CITY OF STOUGHTON, 381 E. MAIN STREET, STOUGHTON, WISCONSIN

Resolution by the Common Council of the City of Stoughton
Conditionally Approving the Preliminary Plat of Kettle Park West

PRELIMINARY PLAT OF

KETTLE PARK WEST

EXHIBIT A

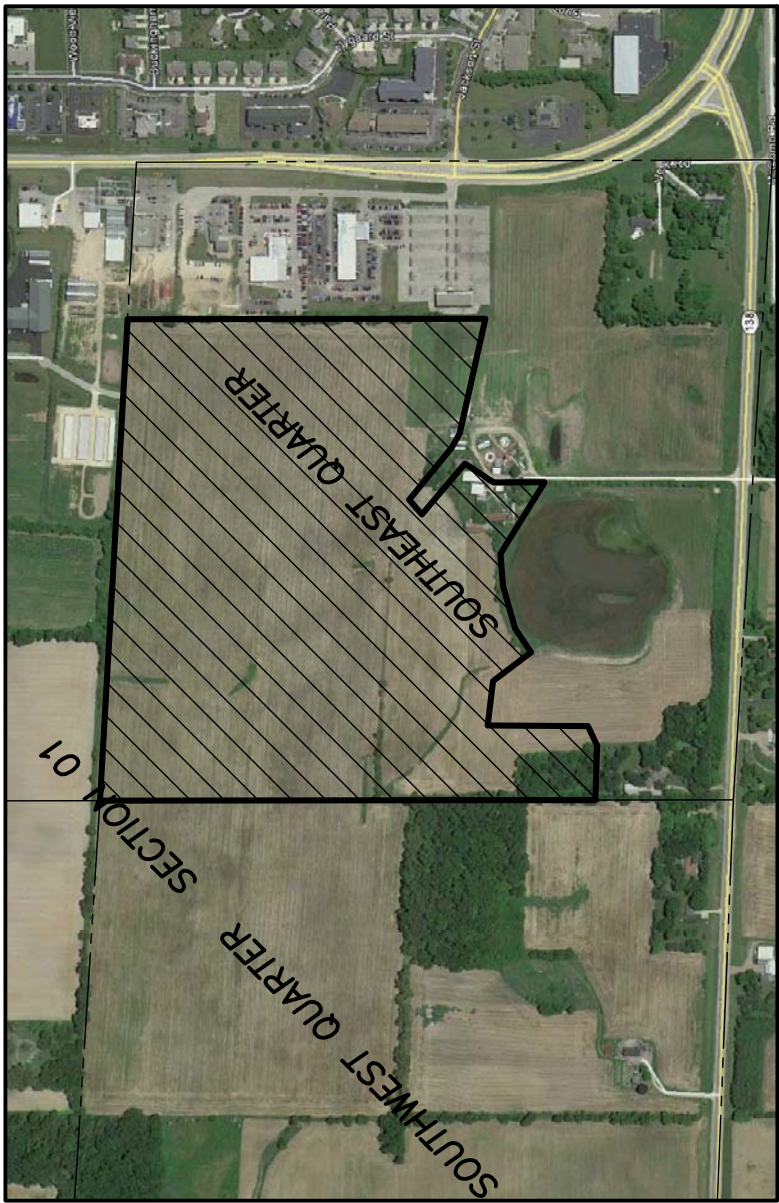
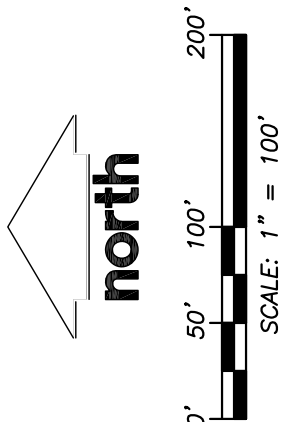
- D. The double frontage of Outlots 4 and 3 are found to be necessary to overcome disadvantages of topography and orientation, pursuant to Section 66.714 of the Stoughton Municipal Code.

- E. Those portions of Wild Senna Trail that fall outside the block-length requirements specified in Section 66.713 of the Stoughton Municipal Code are found acceptable due to limiting factors of good design, pursuant to Section 66.713(b).

2. The City must adopt an ordinance changing the zoning classification of the lots within the Plat as follows:
 - A. Lots 1-12 and ~~29-5630-57~~ must be zoned SR-5 Single-Family Residential 5;

- B. Lots 13 and ~~21-2822-29~~ must be zoned MR-10 – Multi-Family Residential 10;
 - C. Lots 17-20 must be zoned MR-24 – Multi-Family Residential 24;
 - D. Outlots ~~4-41-5~~ and Lot 16 must be zoned I – Institutional;

- ~~E.~~ Lots 14-15 must be zoned PB – Planned Business.;
 - ~~F.~~ Lot 21 is zoned to SR-6 – Single Family Residential;
~~E.~~
3. An agreement that provides access to and connectivity between the proposed “Oak Opening Drive” within the Plat, and Oak Opening Drive and Deer Point Drive within the Town of Rutland continuing to U.S.H. 51, must be approved and executed by the City and the Town of Rutland. The agreement must provide for the improvement of Oak Opening Drive and Deer Point Drive within the Town of Rutland in a manner that is acceptable to the Town of Rutland and the City. The agreement must also contain assurances acceptable to the City that the Town will not act unilaterally in a manner that would prevent Oak Opening Drive and Deer Point Drive from serving as a means of entering and exiting the lands within the Plat, except when necessary for emergency or maintenance purposes. The City shall have no obligation to negotiate or enter such an agreement, except in the manner and on such terms as the City, in its sole discretion, deems appropriate. Improvements within the Town of Rutland shall provide bike/pedestrian accommodations and traffic signals (whether temporary or permanent) at the Roby Road/Deer Point Drive and USH 51 intersection.

~~16.15.~~ Changes to the Preliminary Plat notes are to be changed on the final plat as follows: Note #3 is to indicate both Outlot 4 and Outlot 5 are to be dedicated as Park; Note #4 should be deleted; Note #5 should include Outlot #1
